Kewaunee Nuclear Power Plant
N490, State Highway 42
Kewaunee, WI 54216-9511
920-388-2560

Docket 50-305
Operating License DPR-43
Kewaunee Nuclear Power Plant
Revision 21 of the Operational Quality Assurance Program Description

Description of Revisions to the Kewaunee Nuclear Power Plant

Revision 21

FIGURE 2

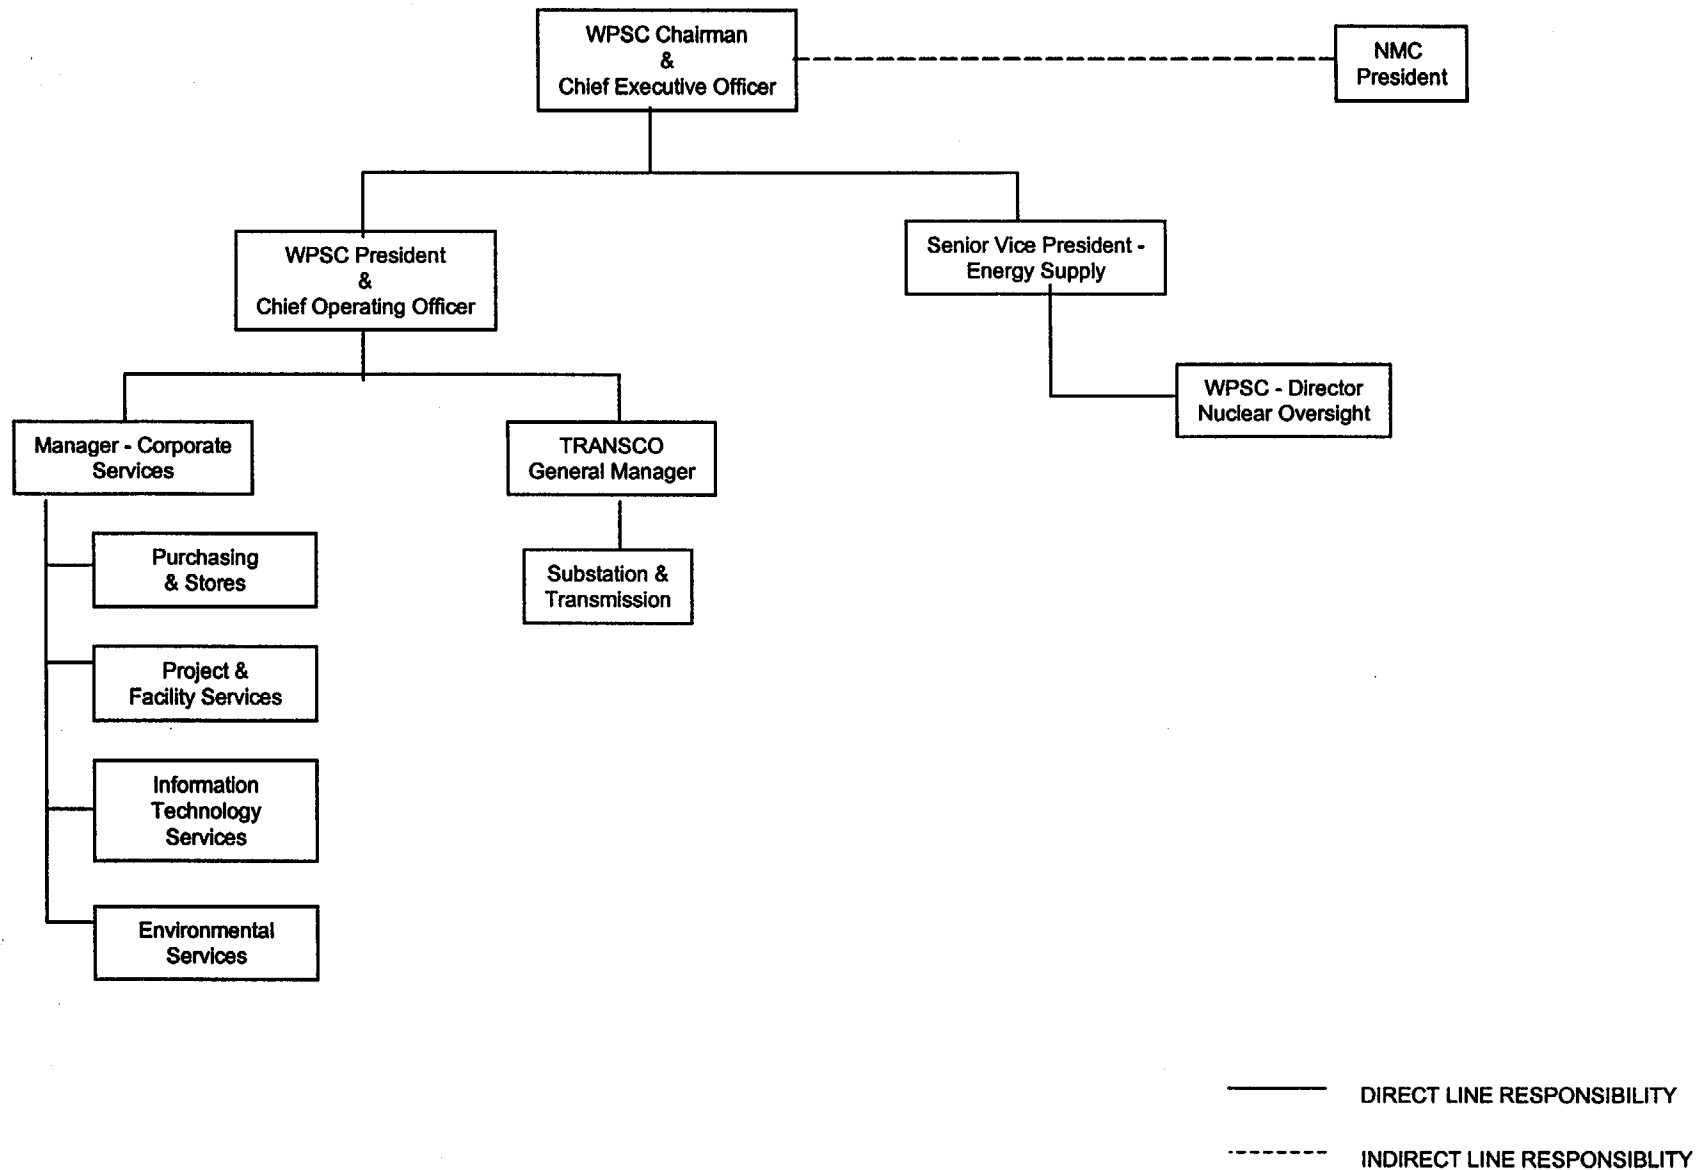
Changed Section 3 heading Duties and Responsibilities – Wisconsin Public Service Corporation Offsite (Figure 2)

Changed "General Manager – Transmission" to "Manager – Substation and Transmission" and added reporting responsibilities.

This is an organizational change due to changes in WPSC. These changes identify the position responsibilities.

FIGURE 3

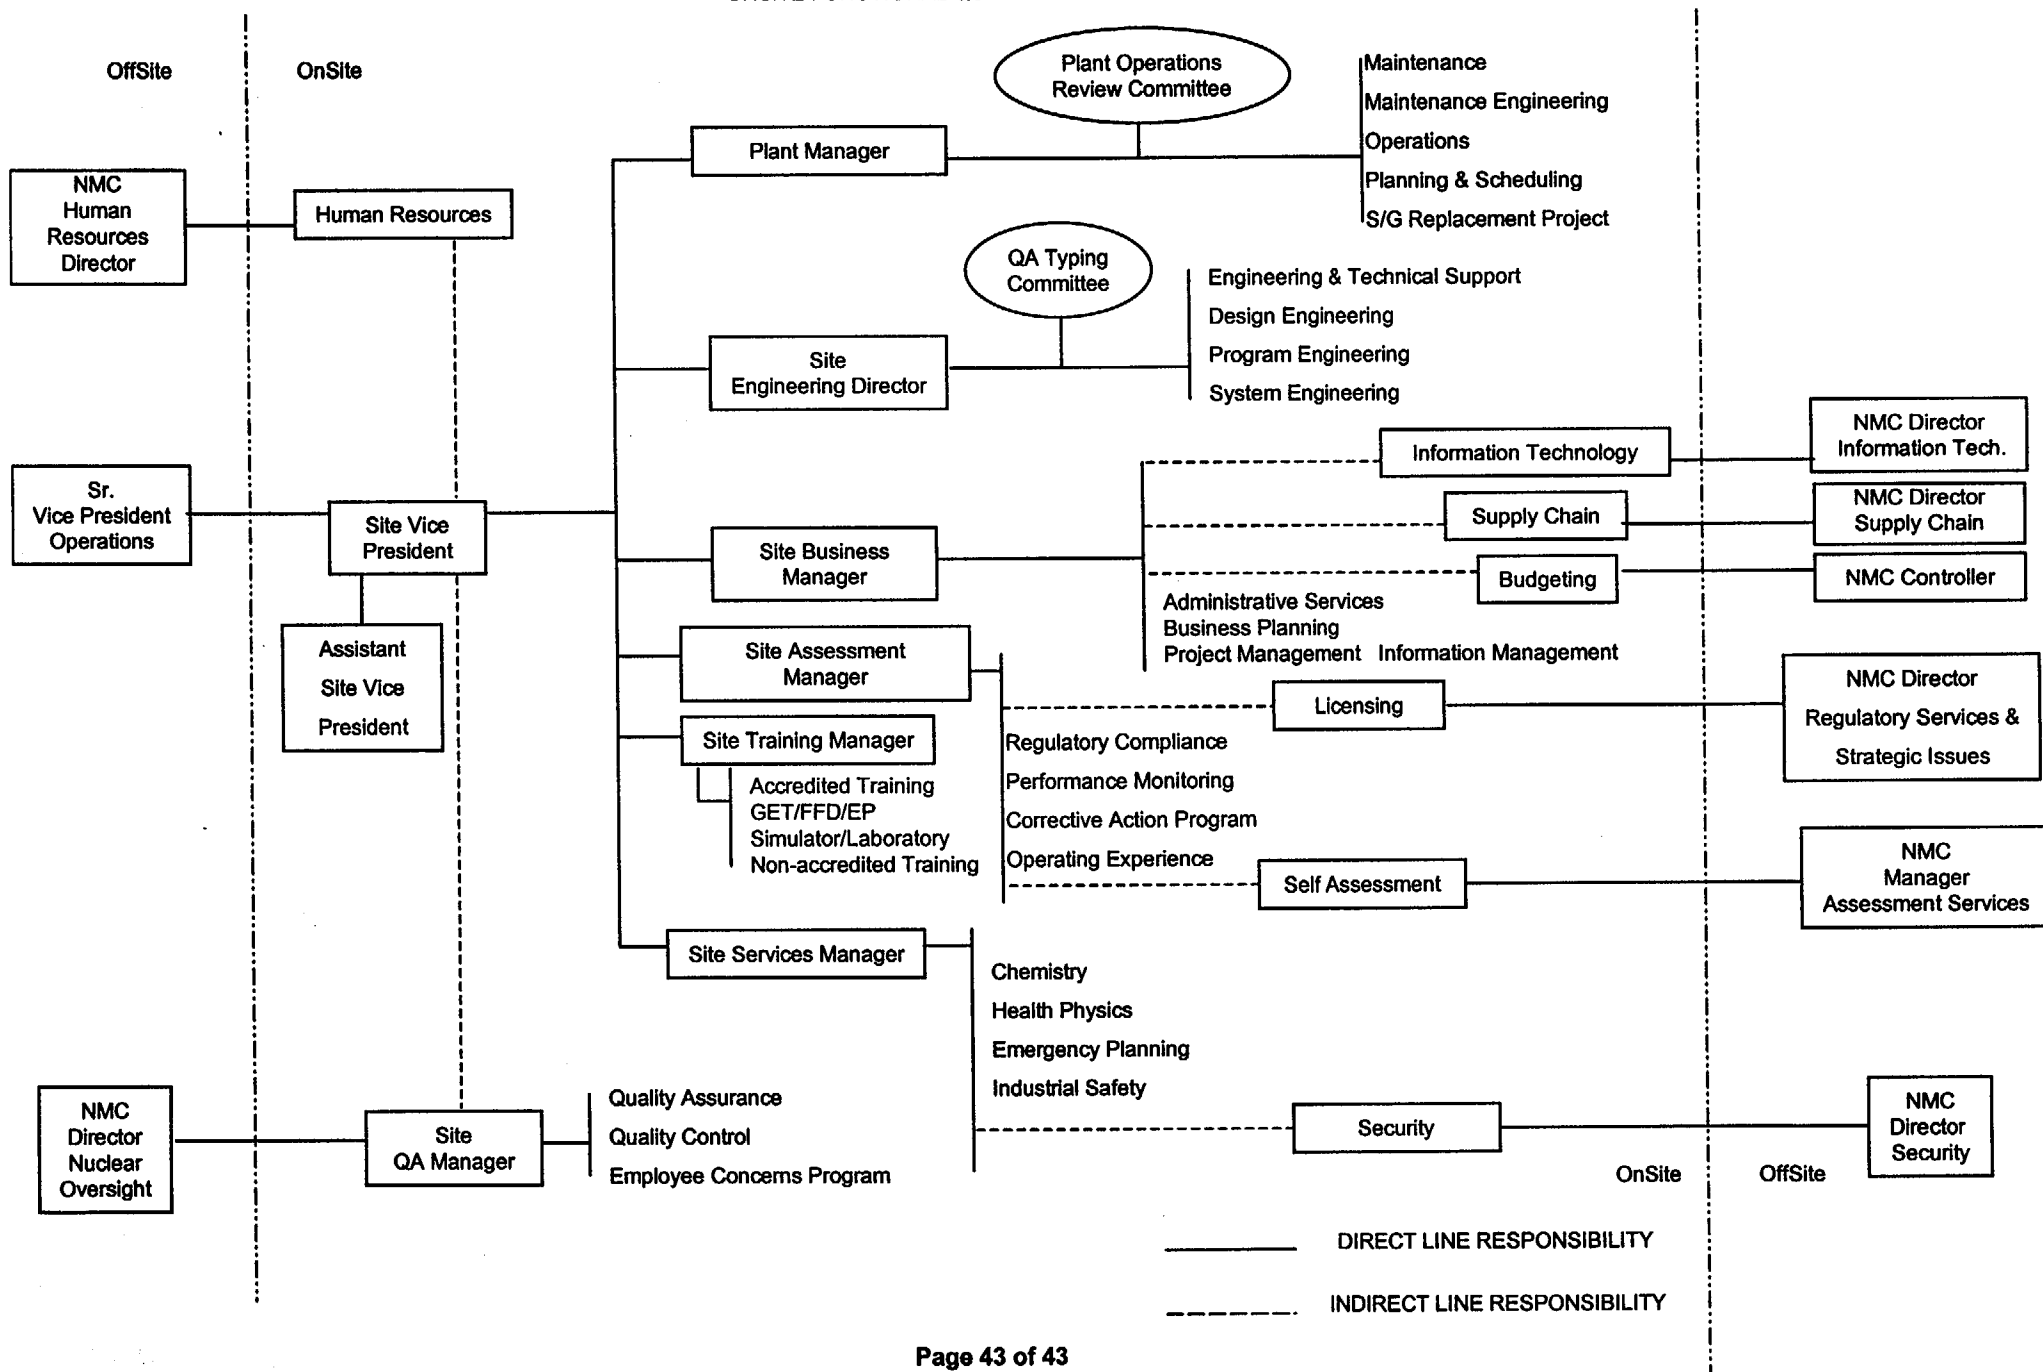
Changed Section 4 heading Duties and Responsibilities – Onsite (Figure 3)

Added "Site Vice President"

Changed title "Manager – Kewaunee Plant" to "Plant Manager"

Under Plant Manager changed title "Vice President - Nuclear" to "Site Vice President"

Changed description of "Plant Maintenance" by removing "supply group activities".

Removed Plant Radiochemistry
